Lake Michigan Shoreline Protection at Promontory Point (Old ProjID:0109170043WCK)
54th to 57th St.

COEC,
IHPA Log #043091701

July 25, 2005

TYPICAL SOUTH FACING SECTION

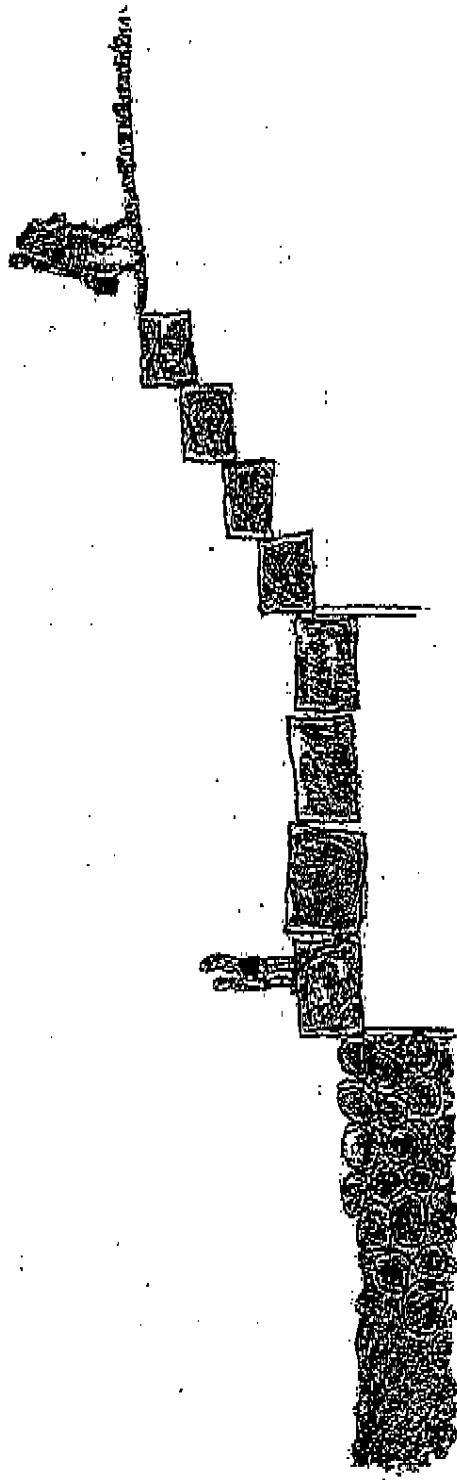
- The IHPA accepts the definition of the restoration zone from Station 1231+00 to Station 1239+00. This area of the south side of Promontory Point will be retained in its current form. ~~The use of pile and/or stone protection~~ lakeward of the existing stone structure is acceptable, but should be designed to have minimal visual impact on the restored zone.
- The accessible path along the lakeshore shall be behind the revetment of the restored zone. The design of the transition between the lower path and upper path is still to be reviewed. Details of the access path design and stabilization treatments needed for this area shall be reviewed by IHPA at the 50% and 95% stages. Review of final documents may be required if changes are requested at the 95% review stage.
